ACCESSION NBR: 8404260049 DOC. DATE: 84/04/19 NOTARIZED: NO DOCKET #
 FACIL: 50-316 Donald C. Cook Nuclear Power Plant, Unit 2, Indiana & 05000316
 AUTH. NAME AUTHOR AFFILIATION
 ALEXICH, M.P. Indiana & Michigan Electric Co.
 RECIP. NAME RECIPIENT AFFILIATION
 DENTON, H.R. Office of Nuclear Reactor Regulation, Director

SUBJECT: Revised application for amend to License DPR-74, providing
 addl info on frequency for torque testing ice condenser
 inlet doors & capability to isolate containment svc air. Rept
 on test dates & drawing of isolation valves encl.

April 19, 1984
AEP:NRC:0860G

Donald C. Cook Nuclear Plant Unit 2
Docket No. 50-316
License No. DPR-74
AMENDMENT TO TECHNICAL SPECIFICATION CHANGE REQUEST

UNIT #1. LOWER ICE CONDENSER
 Door 3-R 4/10/79
 KAT.

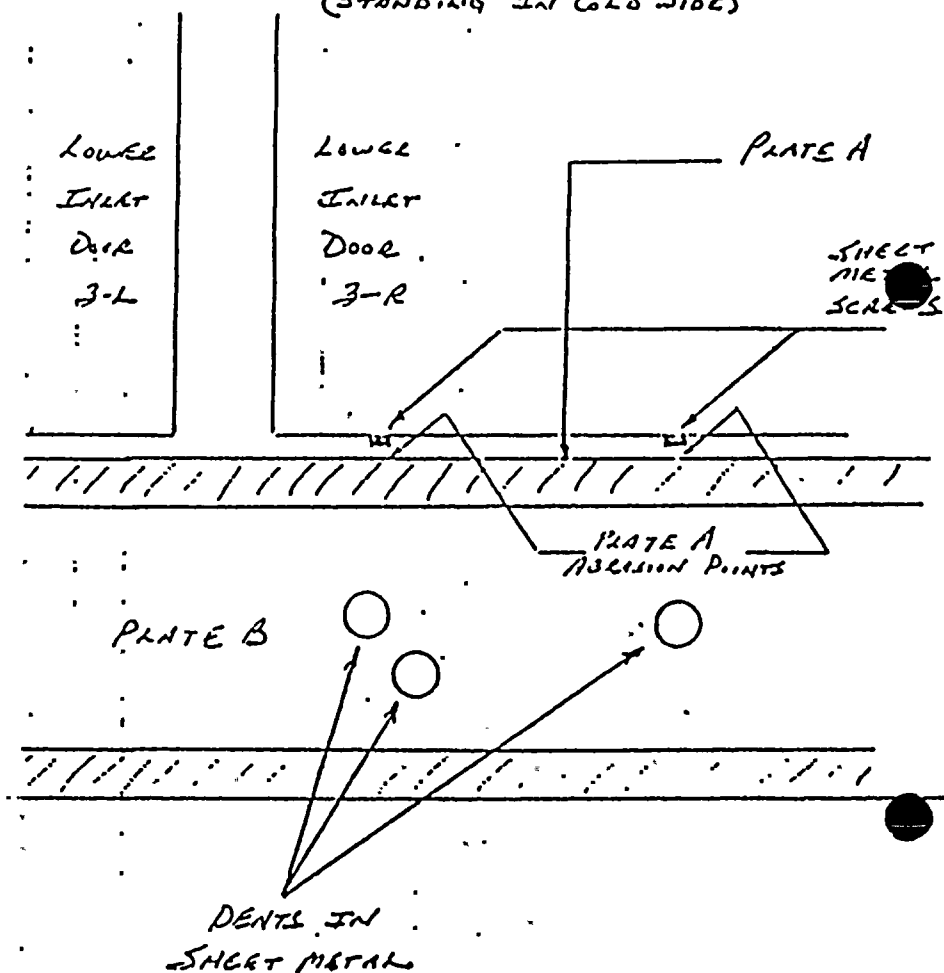
- 1) abrasion marks appeared on the door frame bottom ledge where two of the door's sheet metal screws were making contact as the door was opened,
- 2) large dents in plate B were observed directly below the abrasion points thereby suggesting that a mechanical force, imparted on plate B, may have resulted in forcing plate A upwards and also increasing the size of the gap between plates A & B,
- 3) the RTV sealant, previously installed in the gap between plates A & B, was found missing thereby allowing the possibility of condensation to run from atop plate A down into the insulation to freeze and push plate A upwards and
- 4) mineral residue, indicating condensation flow across plate A (from warm side to cold side) and down toward the gap between plates A & B, was observed.

Based on the observations made during these inspections, it is apparent that door 3-R plate A was forced upwards (and in contact with the door's sheet metal screws) as a result of a combination of mechanical impact transmitted from plate B and insulation expansion as a result of freezing condensation. During the insulation, it became obvious that not only did the blows to plate B force plate A upwards but also resulted in widening the gap between plates A & B which resulted in a high probability of increasing condensation flow into the insulation.

* CONTACT BETWEEN THESE TWO POINTS
 INDICATED BY ABRASION MARKS
 ON FRAMING LEDGE (PLATE A)

To completely eliminate the possibility of this problem in the future, a RFC has been written to replace the horizontal plate A with a plate that would slope down in the direction as shown in Attachment #2. The sloping feature of the this plate would provide a significantly greater clearance between the plate and the door's sheet metal screws. The greater clearance will allow plate B to absorb impact without causing plate A to interfere with the door's opening travel. It is planned to install the RFC in each unit during each unit's upcoming refueling outage. (This has been completed)

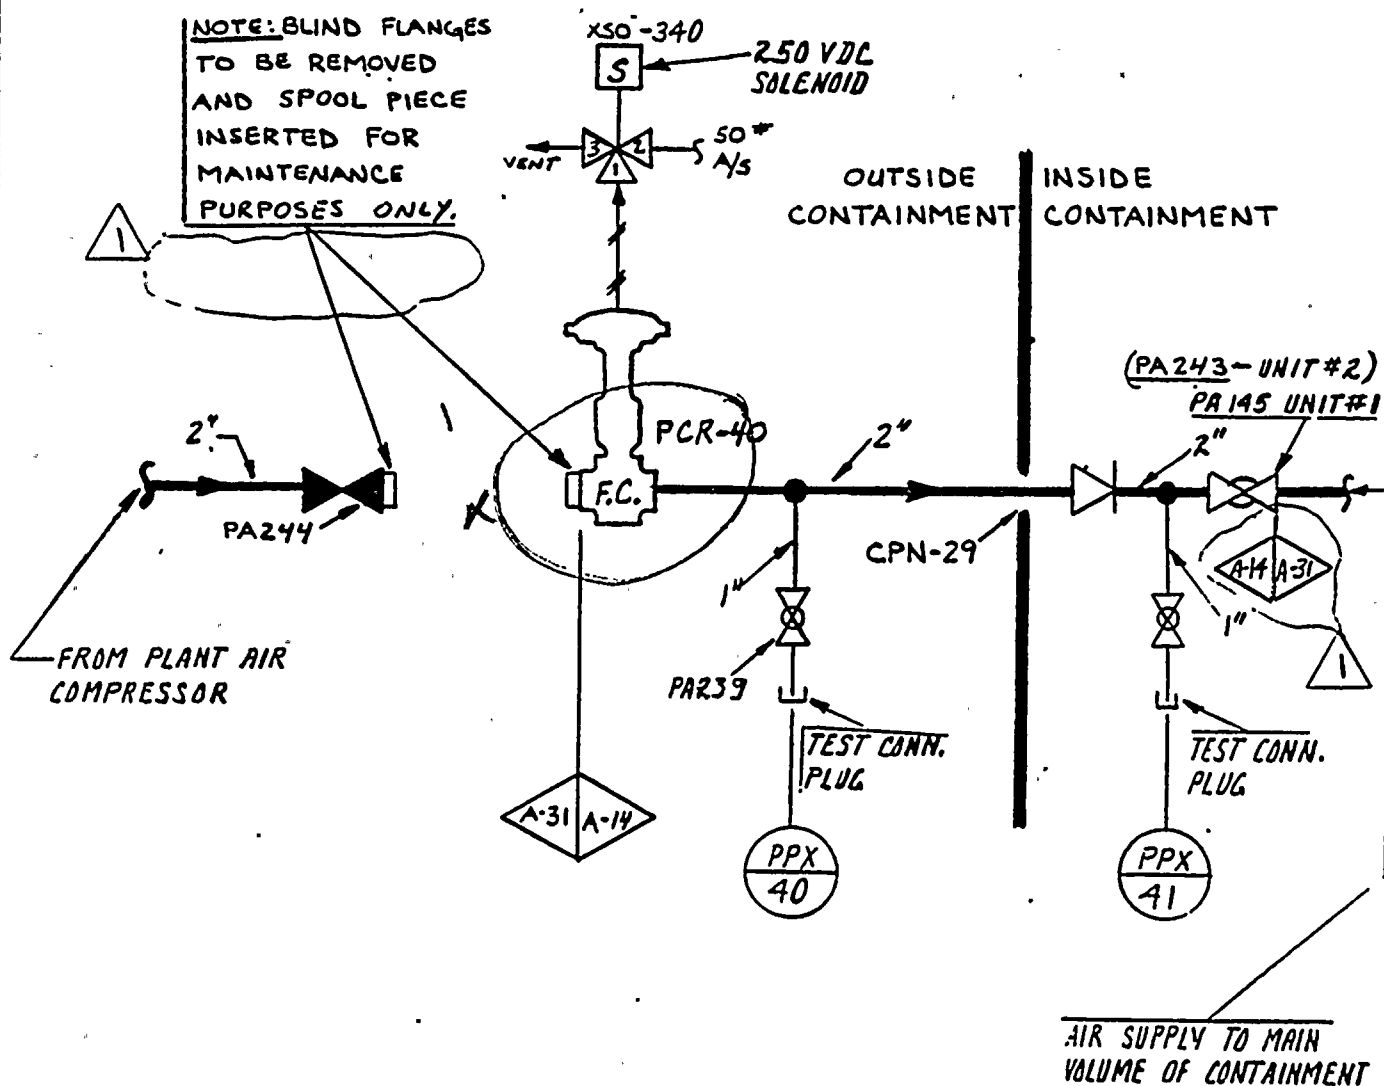
The fourth change involved the capability to isolate containment service air in Modes 1, 2, 3, and 4. Specifically, we requested Table 3.6-1 be changed to add valve PCR-40 to list A and valve PA-342 to list E and to delete valve PA-243 and a blind flange (Item 47) from list E. Attachment 2 to this letter contains a figure and drawing which show the location of the above valves. Figure 9.8.3 from the updated FSAR shows the physical location of the valves. Drawing 1-2-PO-01 shows the isometric location of the valve PCR-40, which would replace a manually operated valve at that location. Upon the initiation of the containment isolation signal, this valve is to close automatically, thus providing containment isolation.
